17 September 2015  
Nuclear Regulation Authority, Japan

## Leakages of water from the dikes in tank areas storing contaminated water at Fukushima Daiichi NPS

### Tank areas & Leakage points

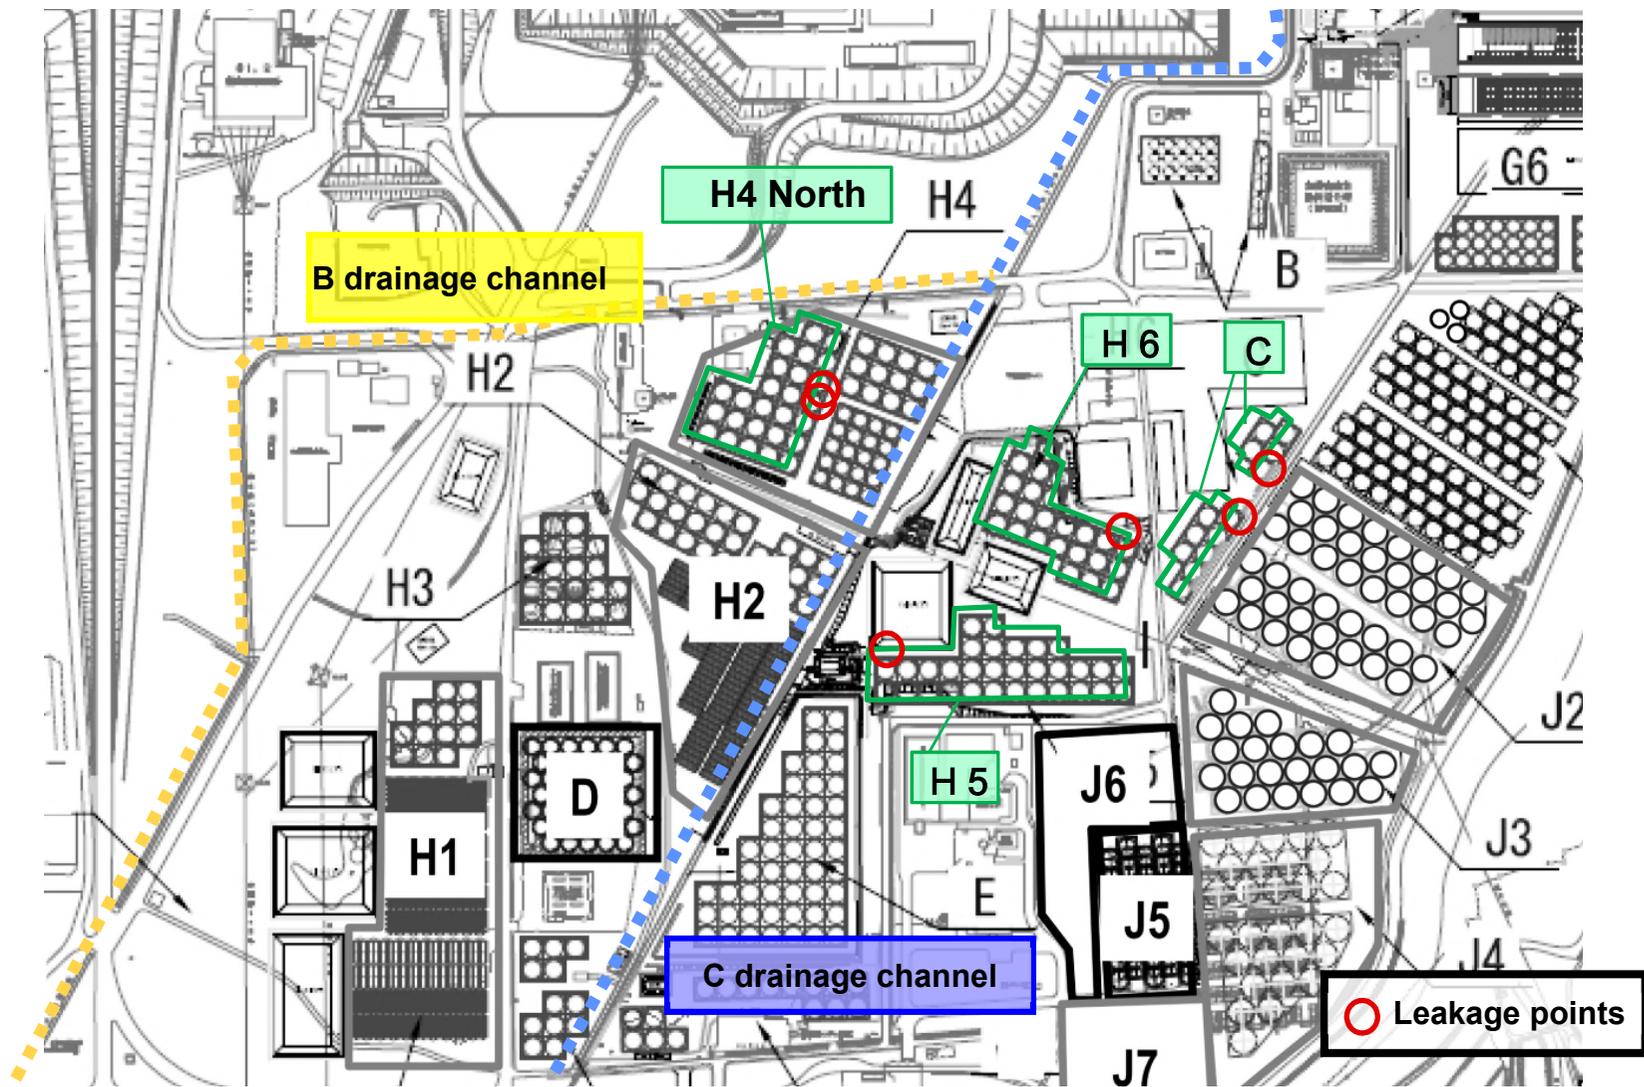
- The report delineates the incident in which water accumulated in the dikes due to rainfall was found to be leaking in 4 areas (H5, C, H6, and H4 North as shown in Attachment\*) between 9 and 14 September 2015.
- The dikes are installed in order to prevent contaminated water from spreading in case a leakage from the tanks would occur. The water levels of tanks in each of the 4 areas show no change, suggesting there are no leakage from the tanks.
- There was no effect on the ocean throughout this incident.
  - At tank areas H5 and C, the concentration of radionuclides in the leaked water was lower than the water flowing through the drainage channels B and C during rainfall.
  - At tank areas H6 and H4 North, water discharge valves had been closed, so the leaked water did not flow into the drainage channels.

1. To continue monitoring including drainage channels monitoring in succession and sampling of groundwater around tank areas;
2. To screen, inspect, and treat the dikes to prevent further leakage;
3. To appropriately manage the water in the dikes taking into account this incident.
